RENESAS TECHNICAL UPDATE

Product Category	MPU & MCU		Document No.	TN-RX*-A114A/E	Rev.	1.00
Title	Corrections to User's Manual regarding the FASR.EXS bit for the Flash Memory in the RX110 Group		Information Category	Technical Notification		
Applicable Product	RX110 Group	Lot No.	Reference Document	RX110 Group User's Manual: Hardware Rev.1.00 (R01UH0421EJ0100) Specification Changes to the RX110 Group (TN-RX*-A112A/E) Corrections to Descriptions for the Flash Memory in the RX110 Group User's Manual (TN-RX*-A113A/E)		
		All

This document describes corrections to the description for the FASR.EXS bit in section 31. Flash Memory of RX110 Group User's Manual: Hardware Rev.1.00.

Figure 31.7 Procedure to Issue the Program Command for the ROM

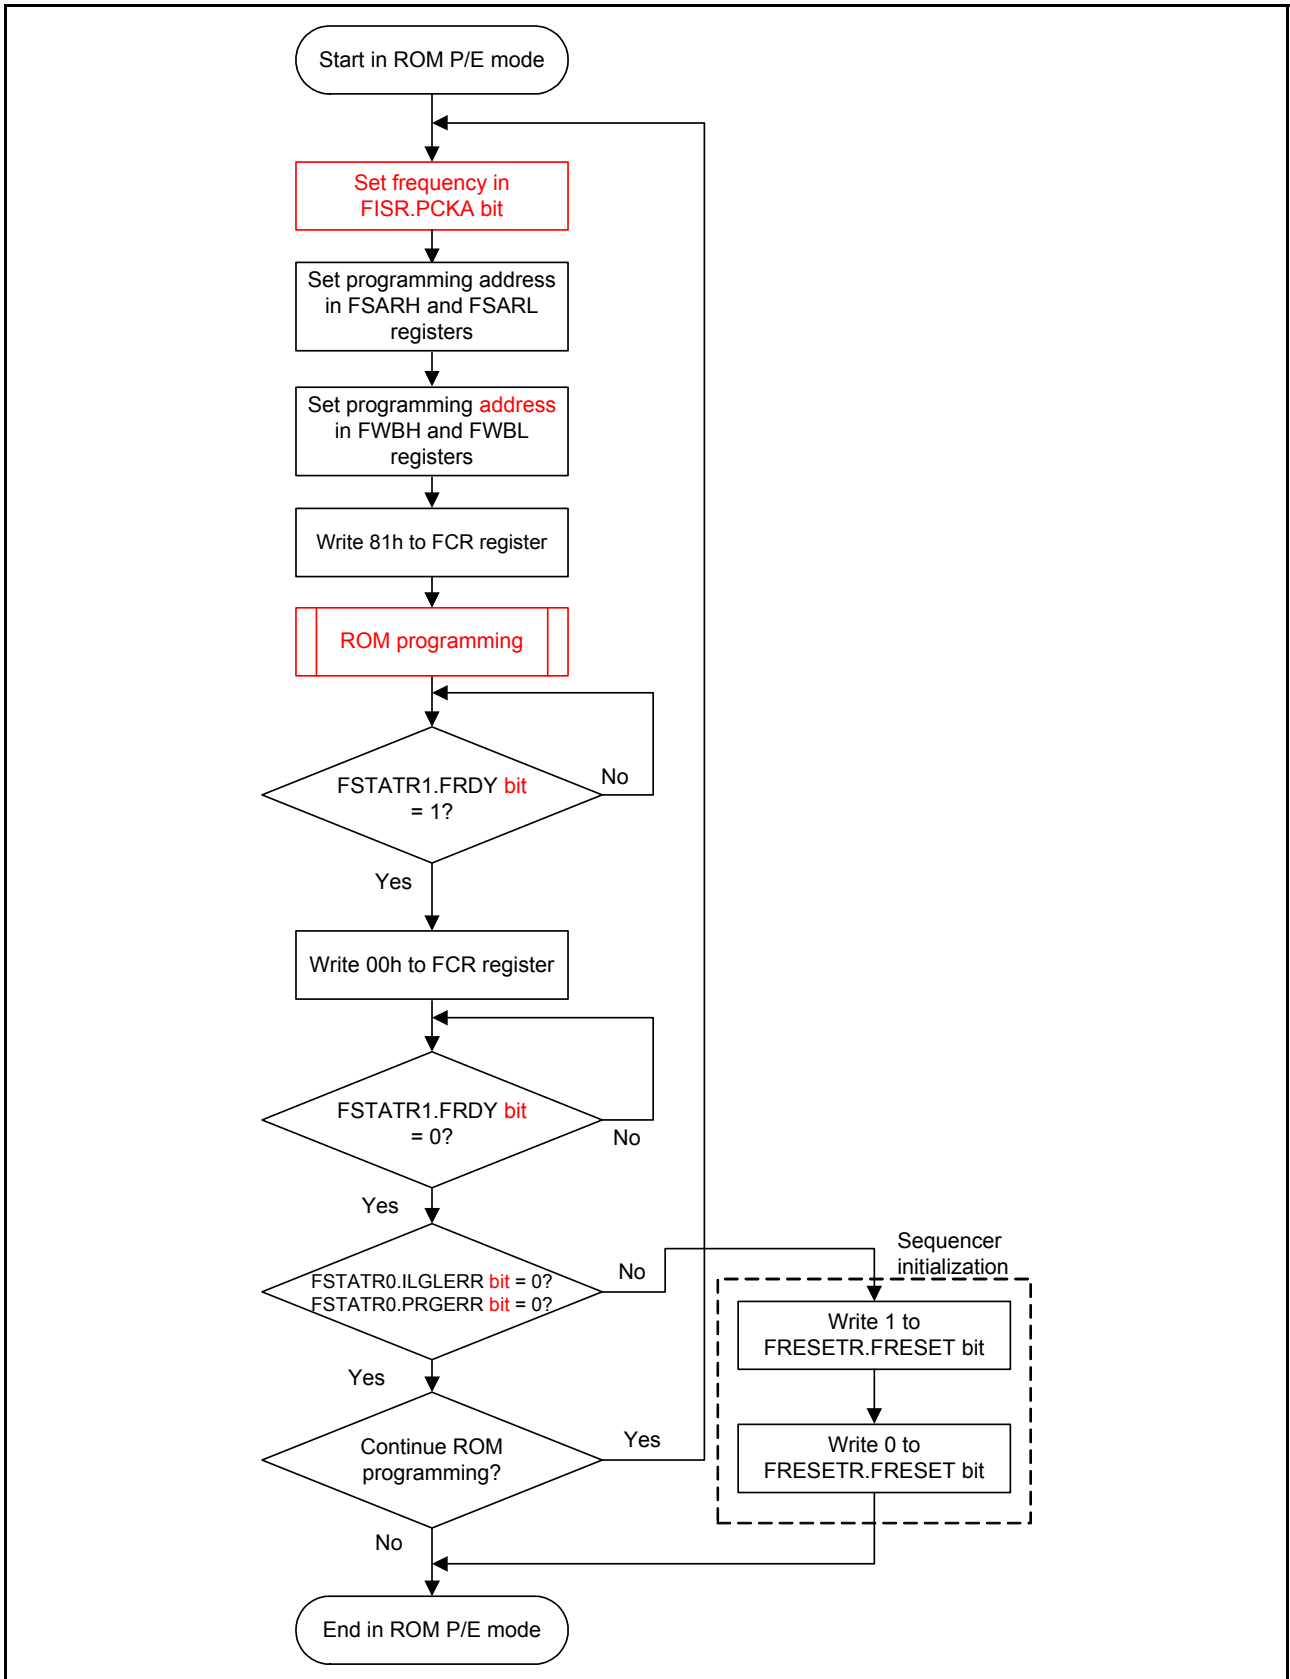
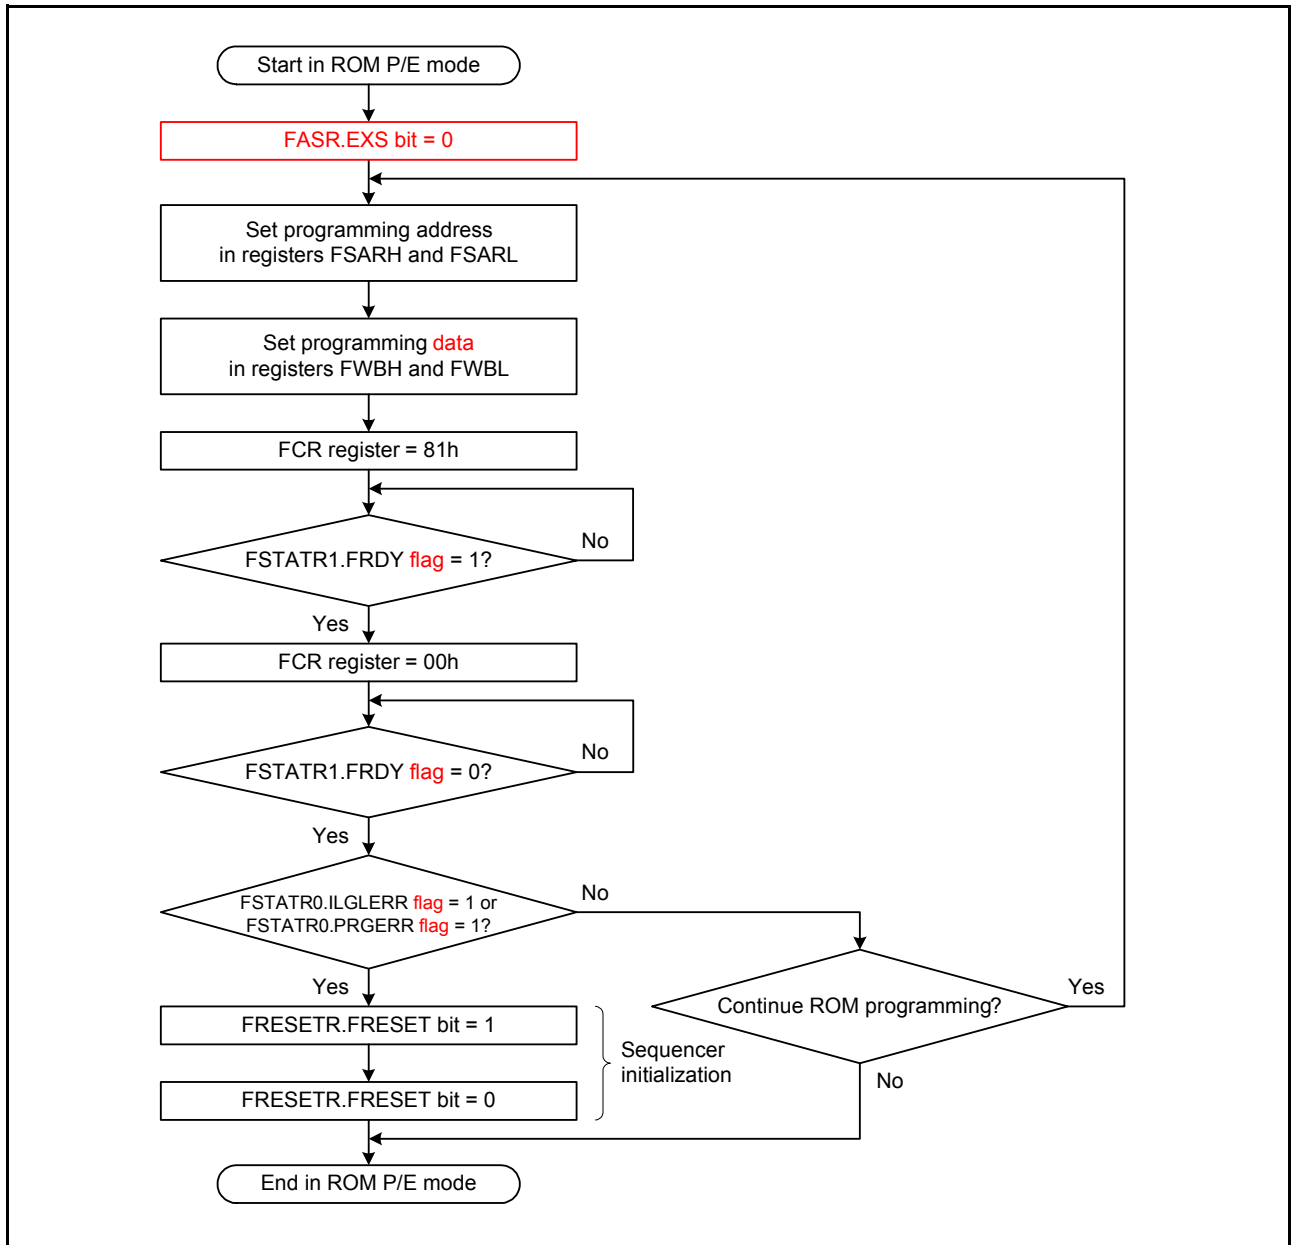
Figure 31.7 in (3) Programming and Erasure Procedures of 31.6.3 Software Command Usage is corrected as follows:

Figure 31.8 Procedure to Issue the Block Erase Command for the ROM

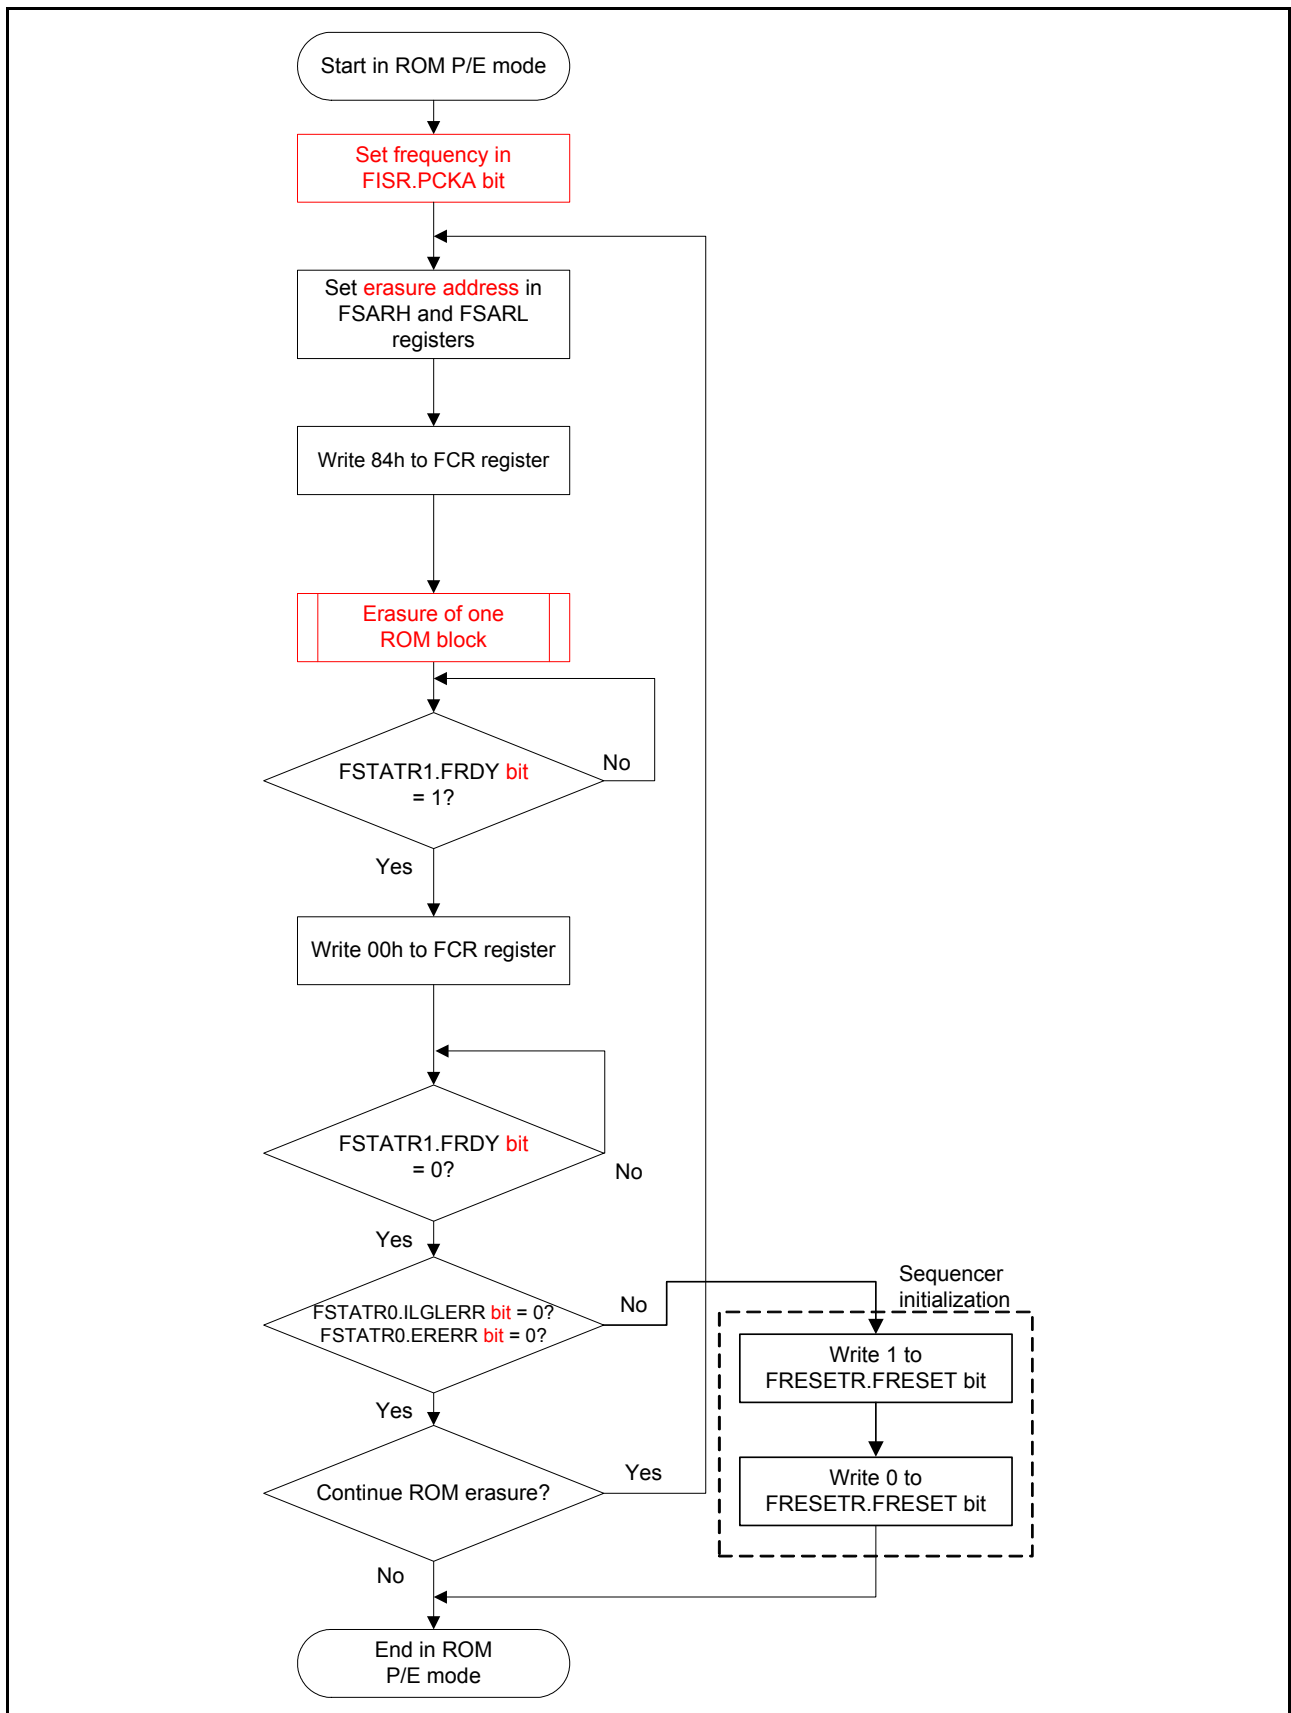
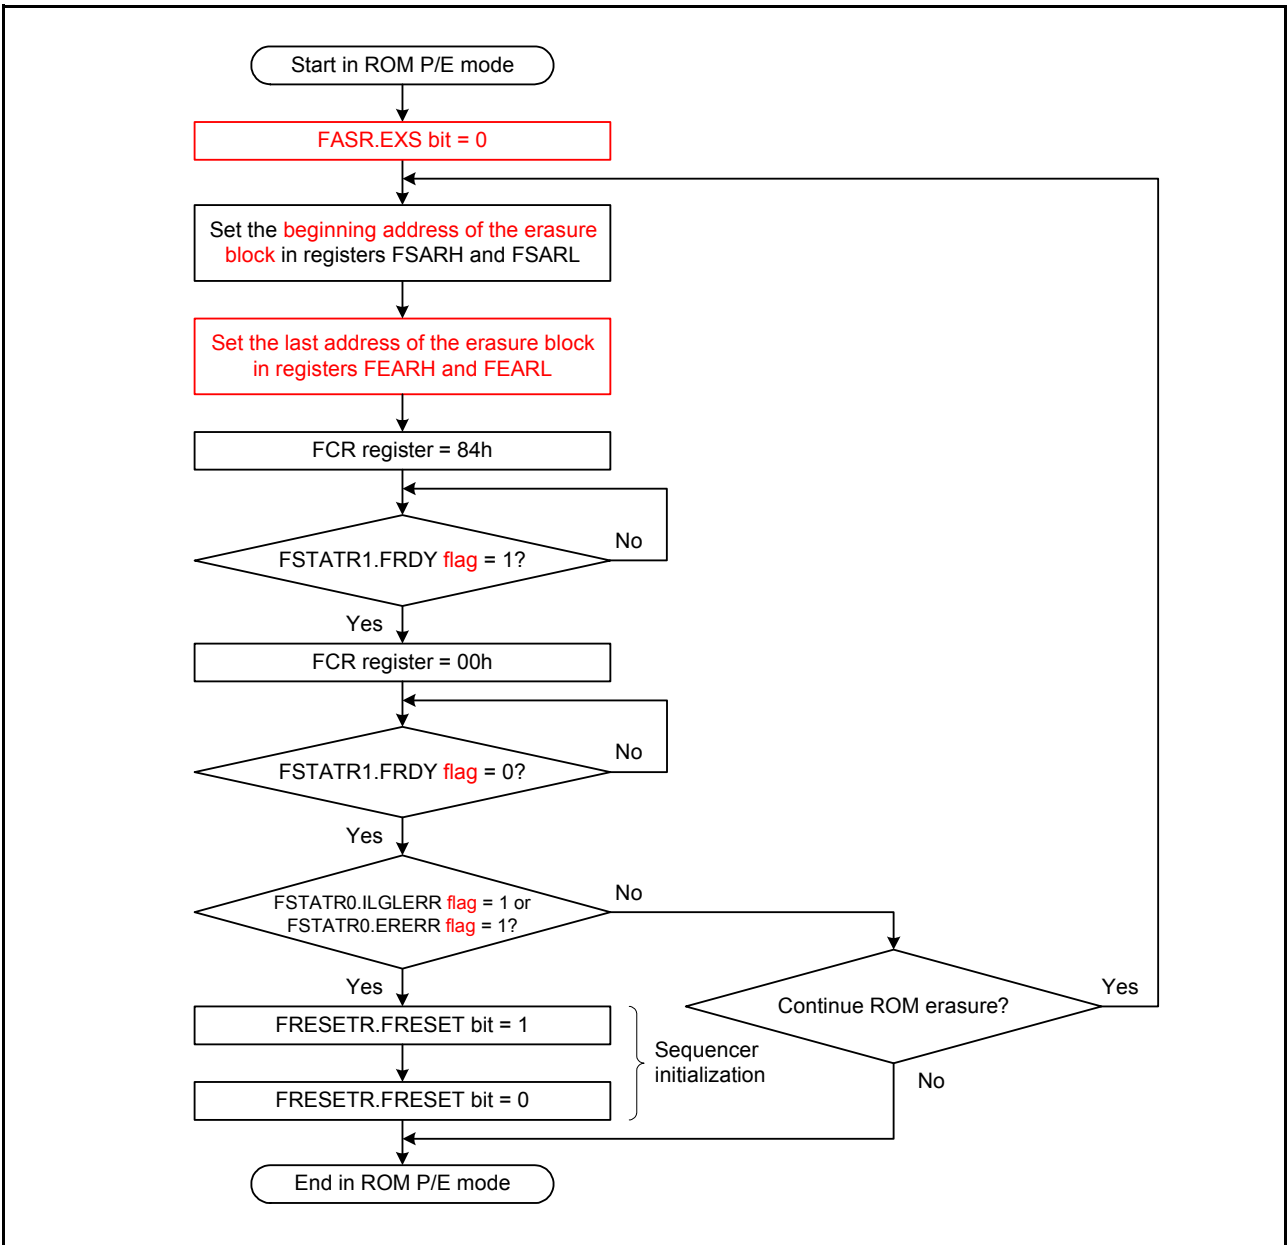
Figure 31.8 in (3) Programming and Erasure Procedures of 31.6.3 Software Command Usage is corrected as follows:

Figure 31.9 Procedure to Issue the Blank Check Command for the ROM

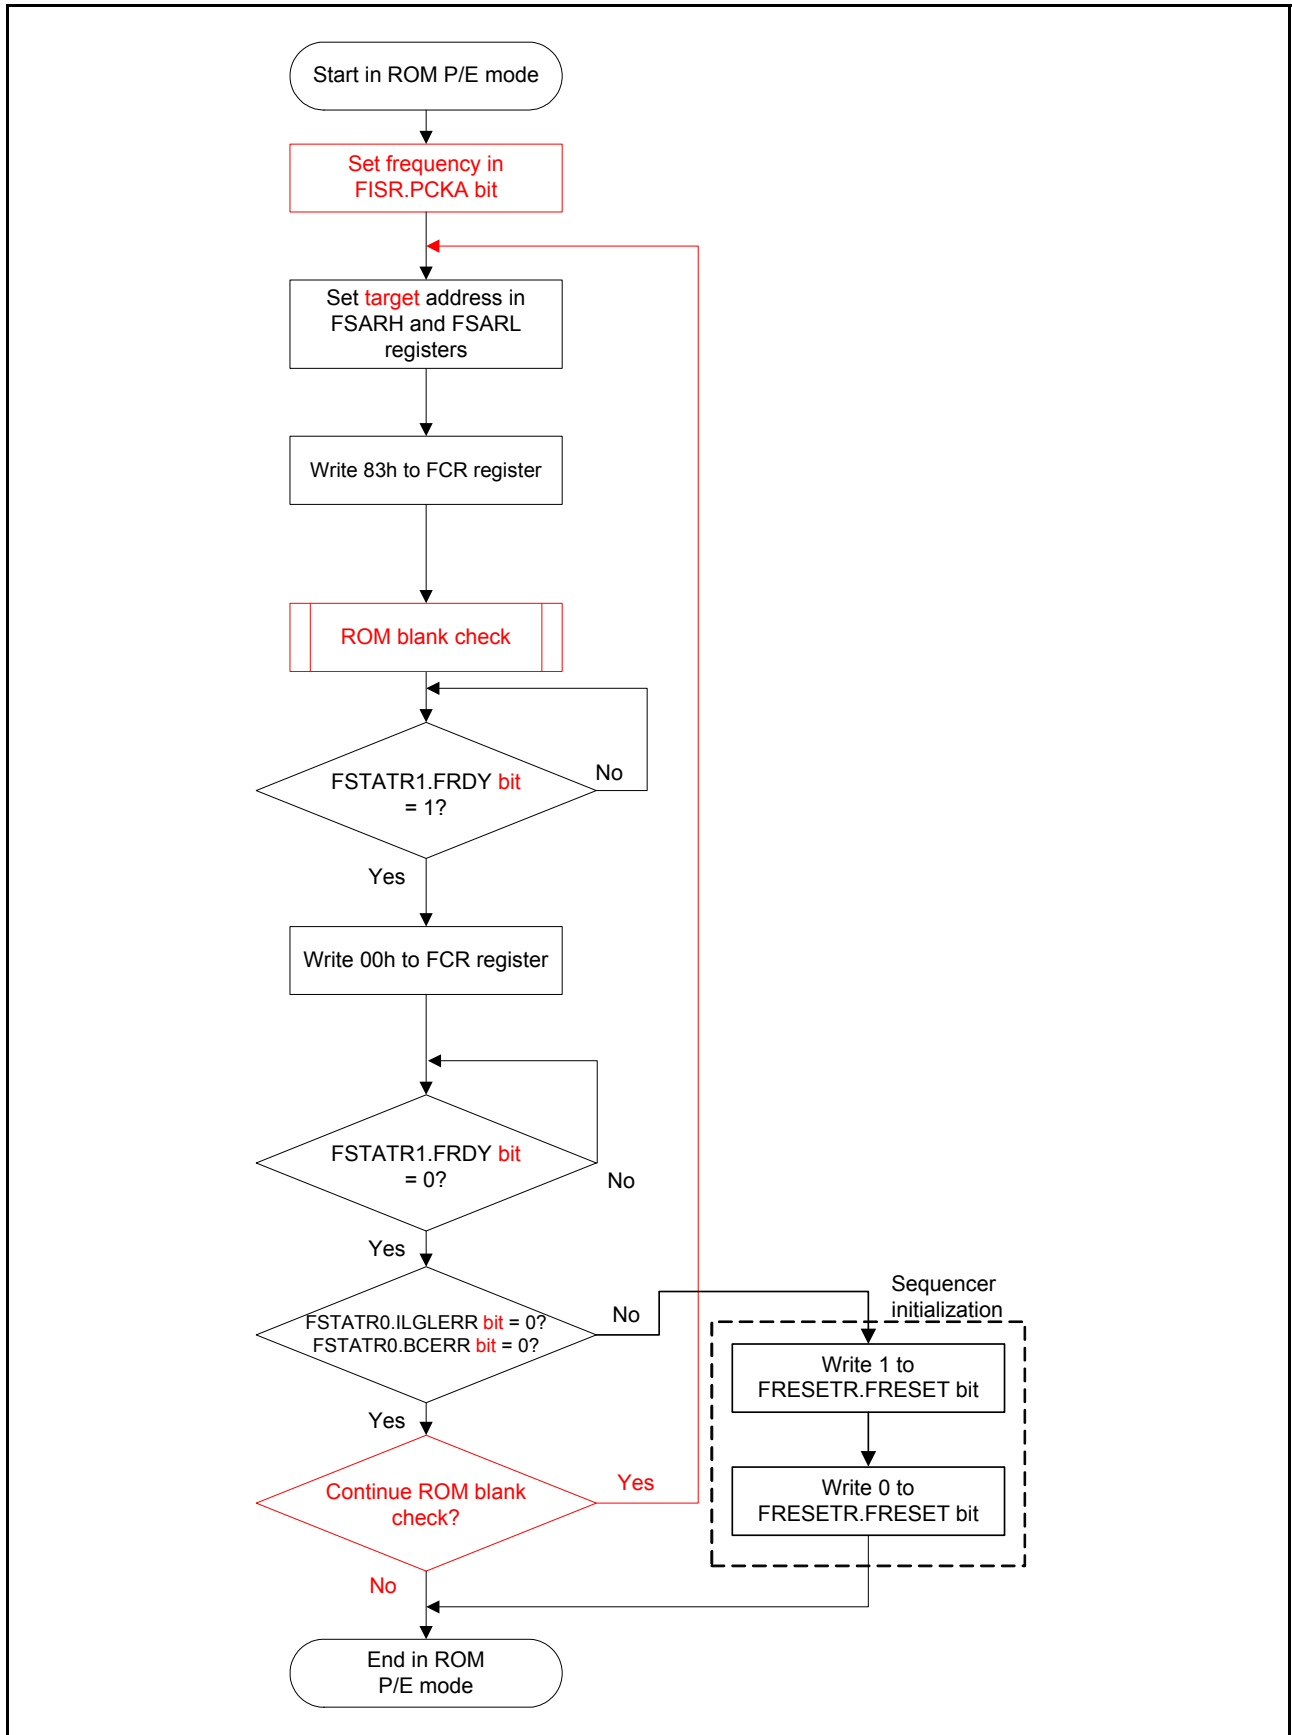
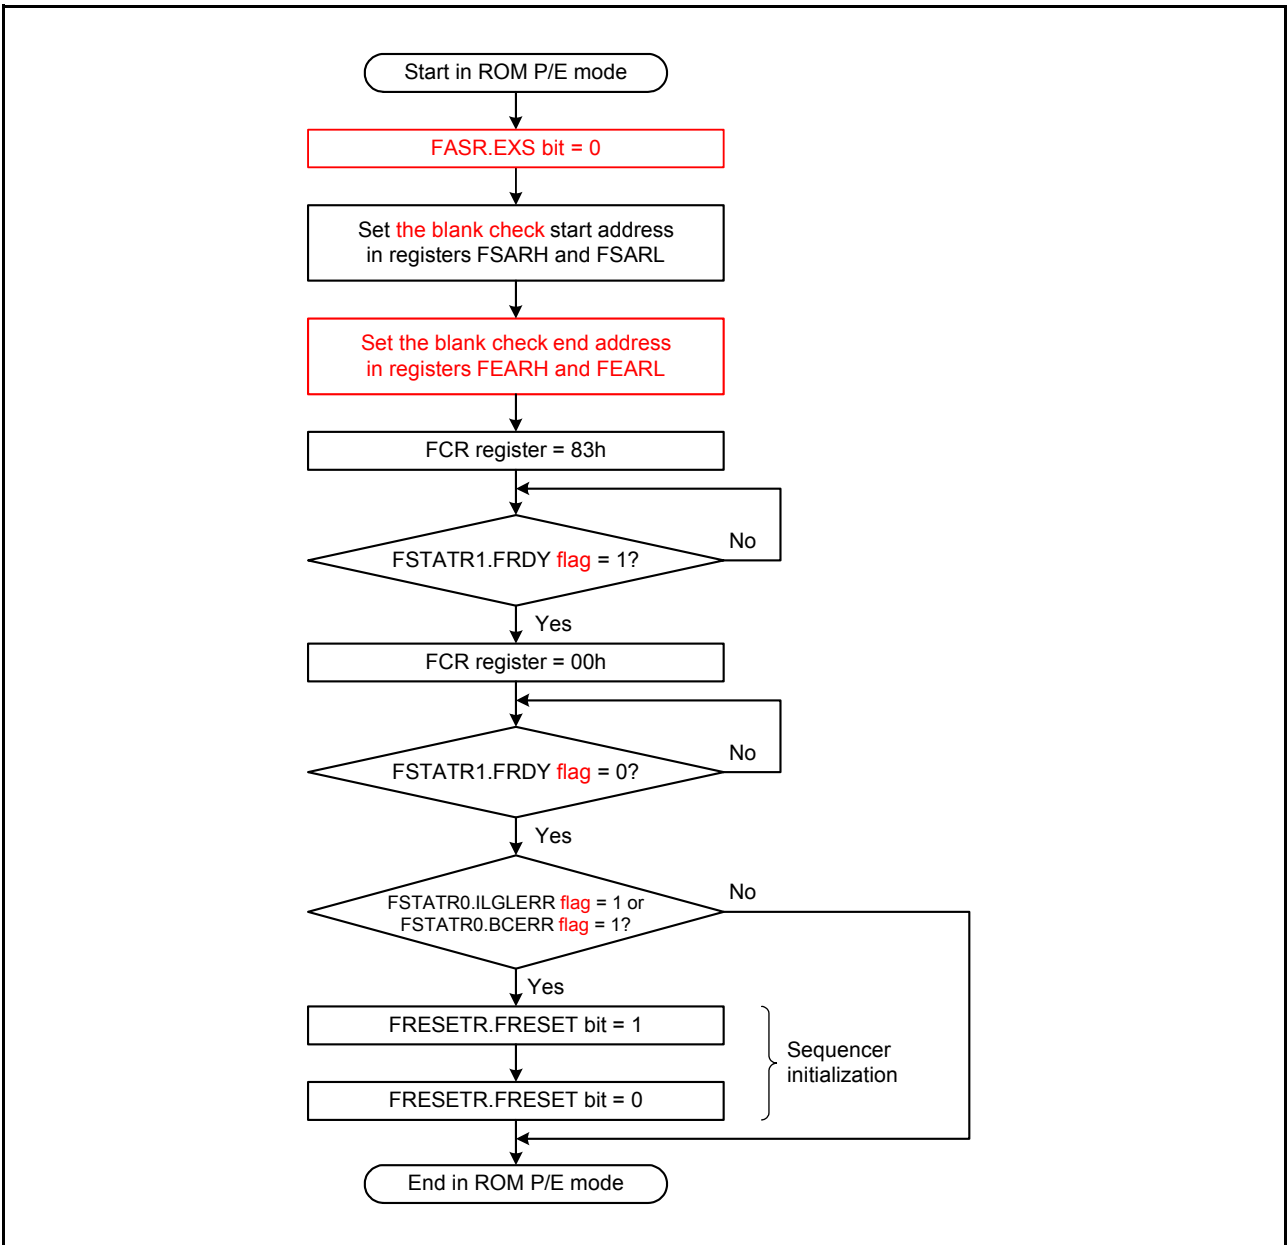
Figure 31.9 in (3) Programming and Erasure Procedures of 31.6.3 Software Command Usage is corrected as follows:
